ADDENDUM NO. 3
to
PLANS and SPECIFICATIONS
for

Medina River Sewer Outfall, Segment 4
SAWS Job No. 12-2504

Issue Date: November 30, 2011

JOB NO.	6866-00
DATE	FEBRUARY 2010
DESIGNER	RRD
DRAWN	BMO
CHECKED	IJC
DRAWING No.	C-84
SHEET No.	25

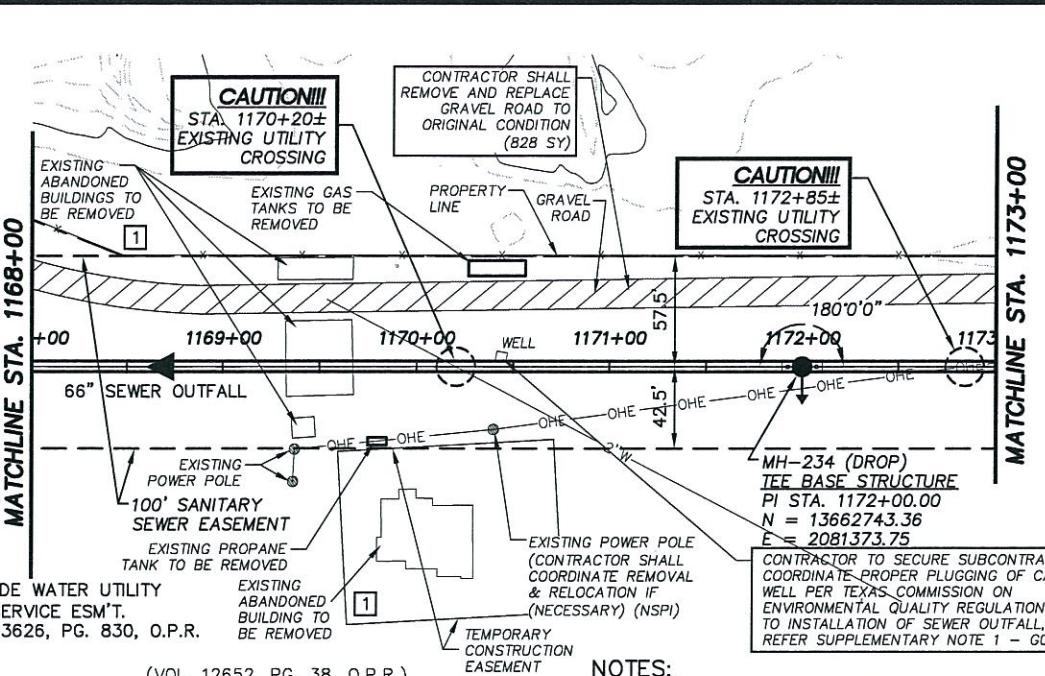
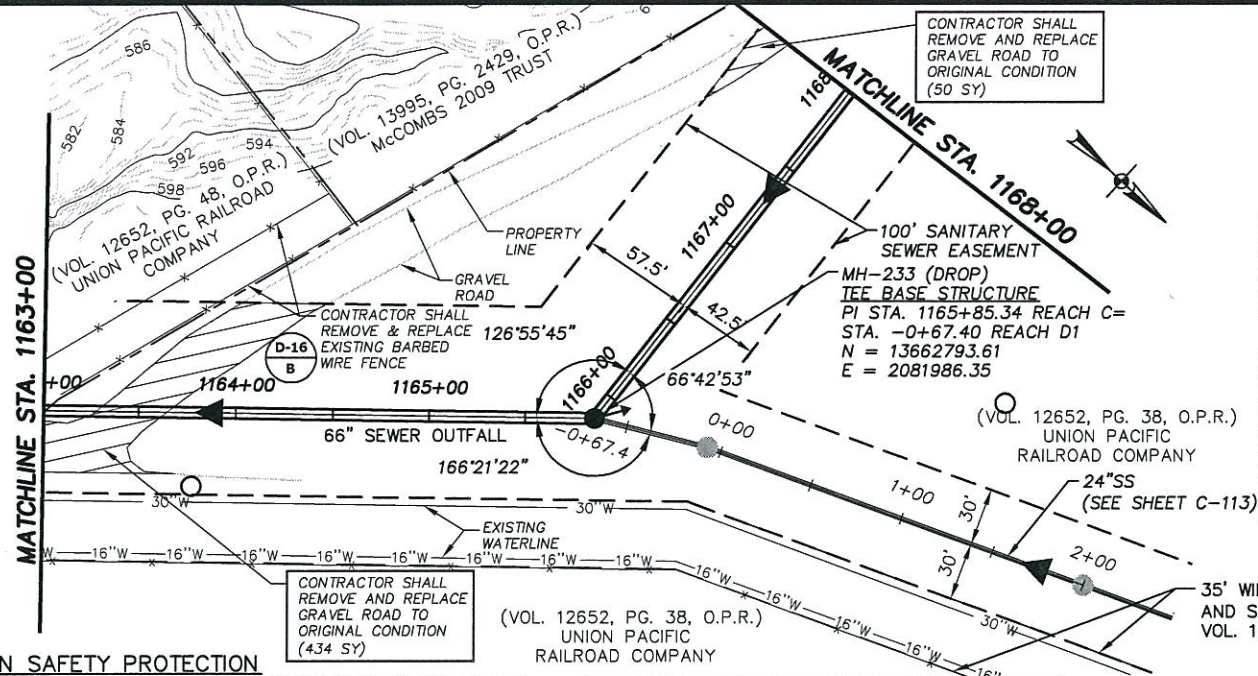
- H. Drawing No. C-74, Sheet No. 25 – Revised Northing and Easting and Stationing on MH 231. Revised MH 231 on profile to correct location and adjusted length between MH 230 and 231 and revised length between MH 231 and matchline at station 1153+00. Remove and Replace this sheet with the attached plan sheet

JOB NO.	6886-00
DATE	FEBRUARY 2010
DESIGNER	RRD
DRAWN	BMO
CHECKED	LJC
DRAWING No.	C-86
SHEET No.	27

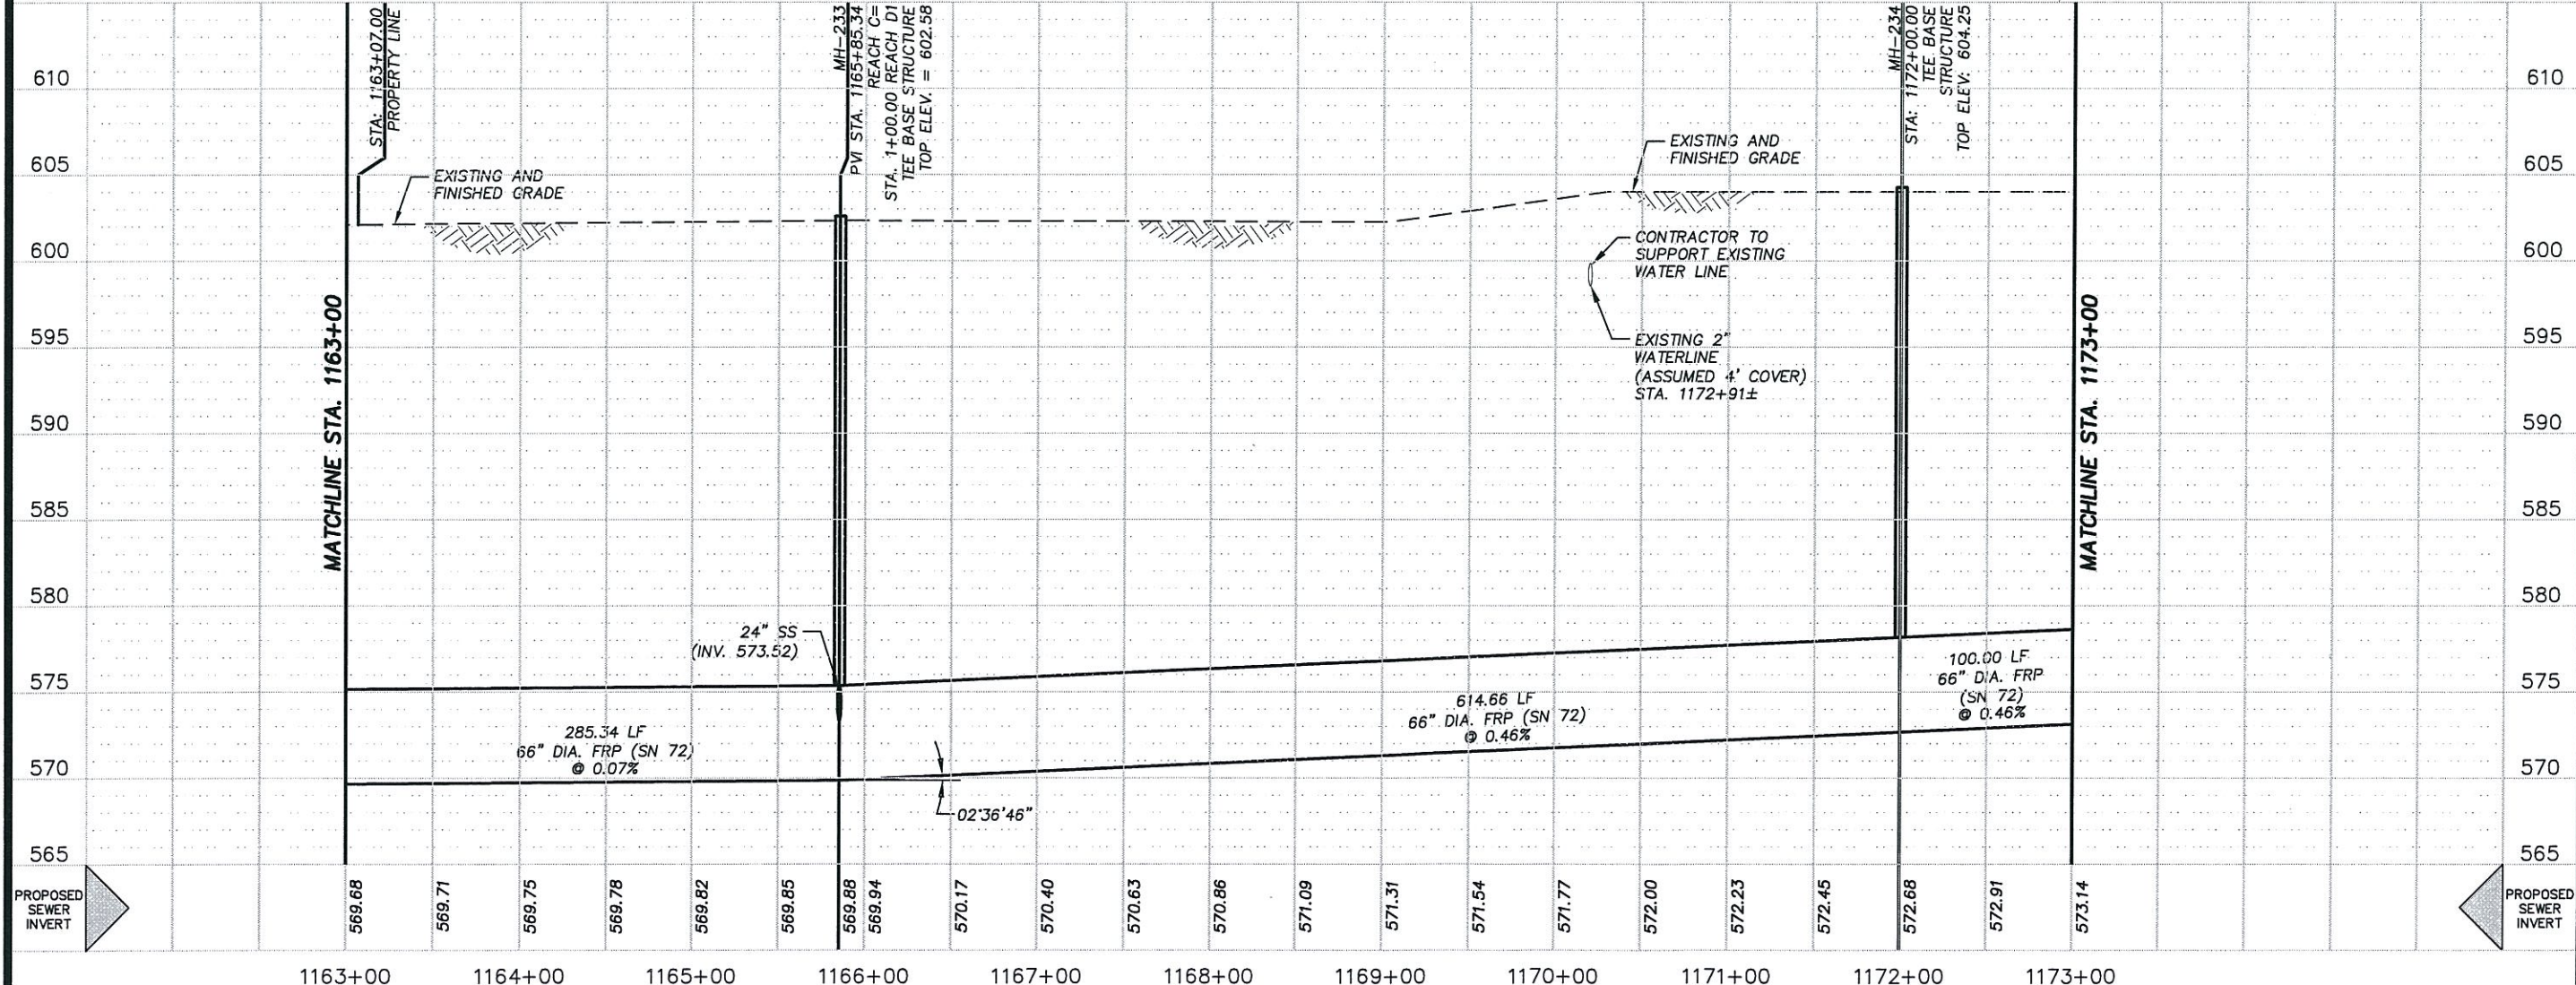
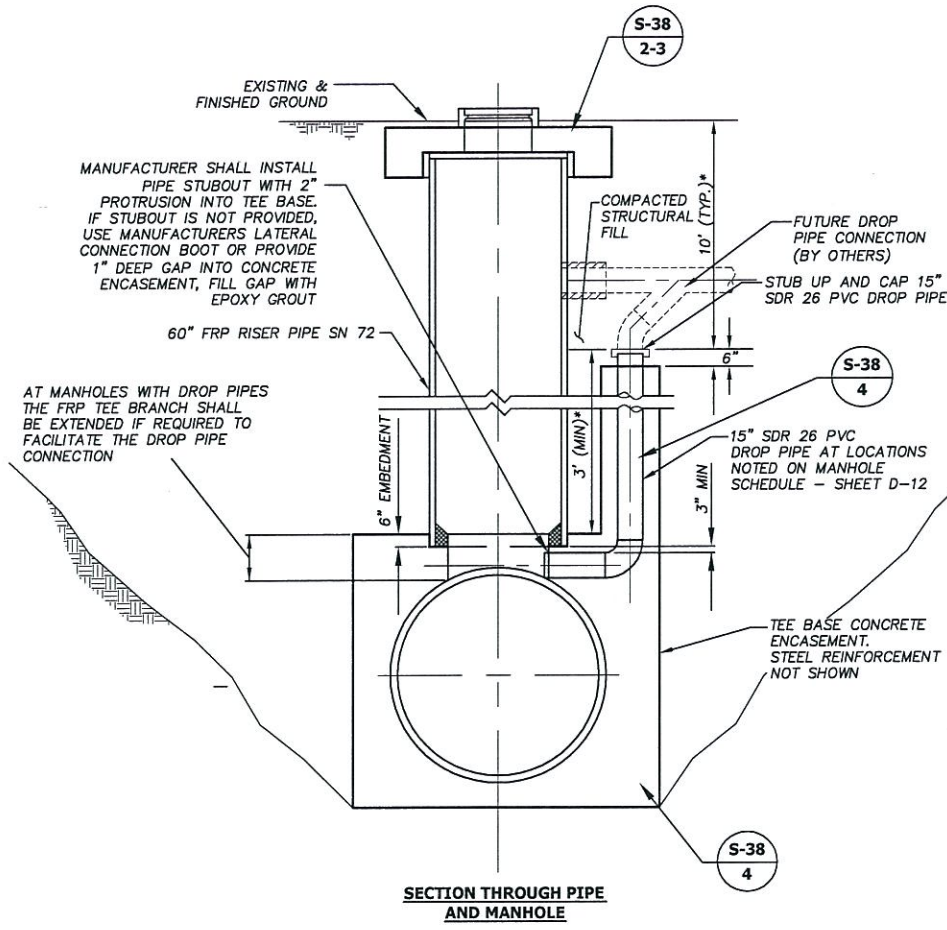
- K. Drawing No. C-86, Sheet No. 27 – Added text (drop) to MH 234 plan view. Remove and Replace this sheet with the attached plan sheet
- L. Drawing Nos. C-113 to C-119, Sheet Nos. 34 to 40 – Remove text on plans for call out of 24" DIA. PVC (SDR 26) pipe, "(160 PSI)" and replace with "(PS 115)".

- N. Question: Please confirm that the Contractor is required to perform all demolition and removal of the (3) buildings, (1) gas tank, (1) propane tank, (1) house shown on Sheet 27.

- X. Question: MH 234 is shown as a drop tee base manhole on the MH schedule (DWG D-12), but is not labeled as a drop manhole on the plans. Please clarify.

Answer: Contactor is responsible for all demolition and removal of the buildings, gas tank, propane tank and house.

Answer: MH 234 is a drop tee base manhole. Drawing C-86 has been revised in section 5.0 Plans of this addendum to reflect this change.

TYPICAL TEE BASE STRUCTURE
N.T.S. (D-11 B)

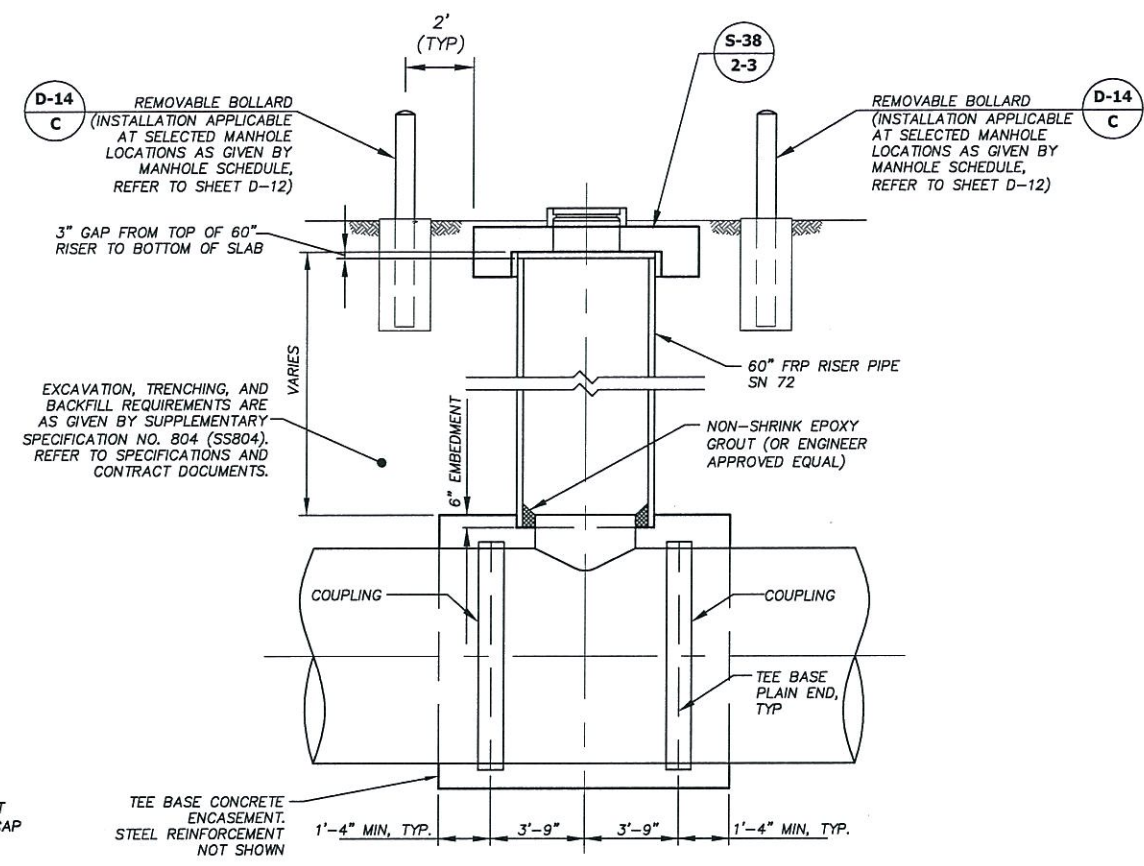
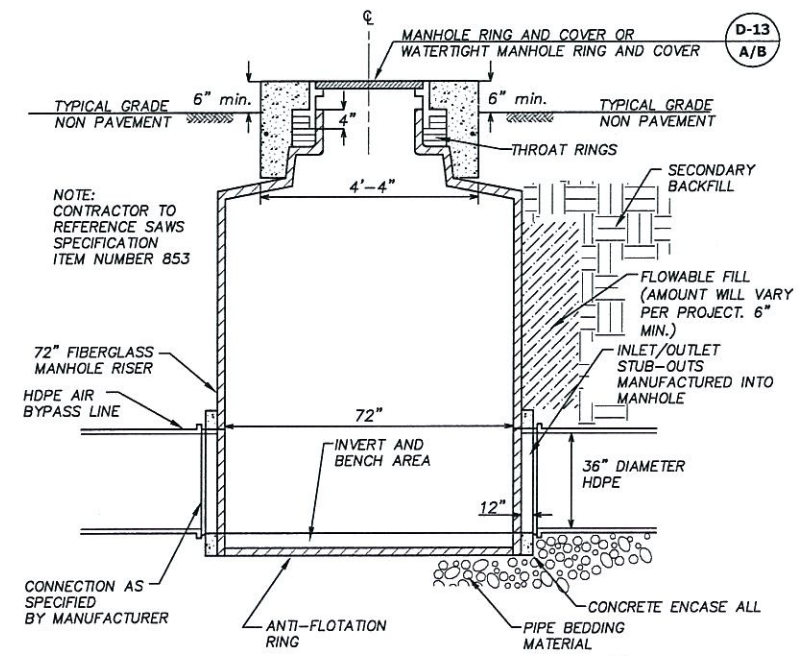
- Q. Drawing No. D-10, Sheet No. 62 – Remove “stainless” from steel casing spacers when indicated on sheet.
- R. Drawing No. D-11, Sheet No. 63 – Revise riser pipe from “SN 46” to “SN 72”. Remove and Replace this sheet with the attached plan sheet.
- S. Drawing No. D-12, Sheet No. 64 – Added X on MH 235 Drop. Remove and Replace this sheet with the attached plan sheet.

- W. Question: There is a difference in pipe stiffness (SN) for the manhole riser pipe in the plans. DWG S-38 shows a pipe stiffness of SN 72 for the manhole riser pipe. DWG D-11 shows a pipe stiffness of SN 46 for the manhole riser pipe. The previous MRSO projects have SN 72 riser pipe being used. Please clarify.

Answer: All pipe stiffness should be SN 72. Drawing D-11 has been revised in section 5.0 Plans of this addendum to reflect this change.

TYPICAL FIBERGLASS MANHOLE DETAIL D-12
N.T.S. A

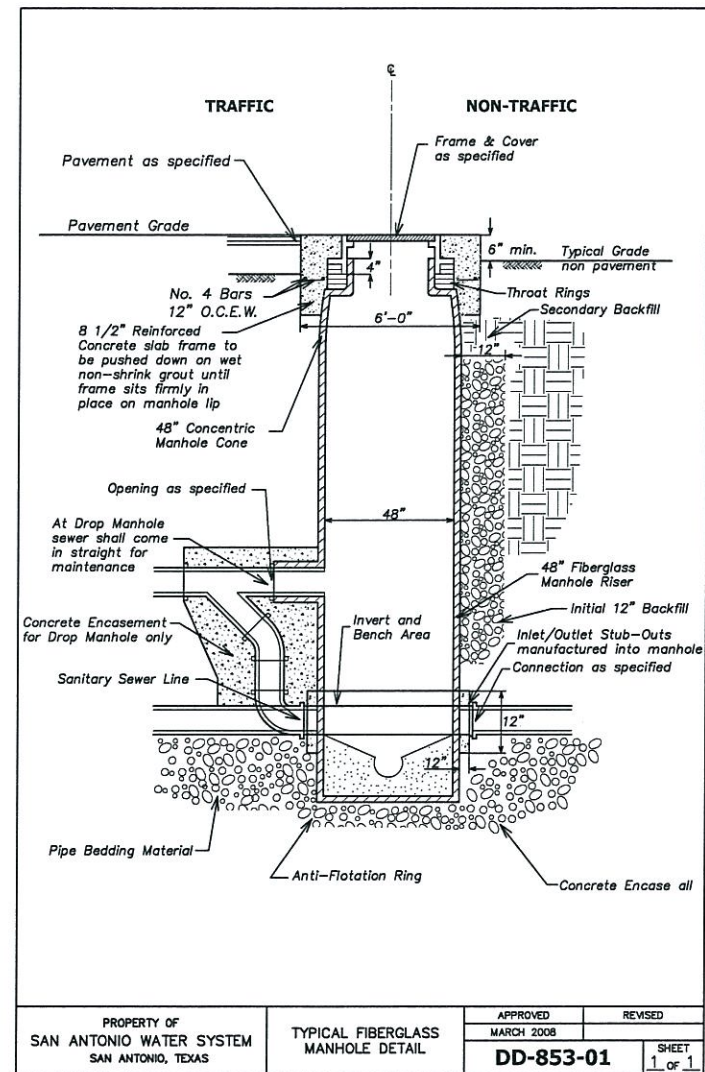
- Y. Question: MH 235 shows no drop on MH Schedule (DWG D-12), but a drop is shown and labeled on the plans. Please clarify.

Answer: MH 235 is a drop tee base manhole. Drawing D-12 has been revised in section 5.0 Plans of this addendum to reflect this change.
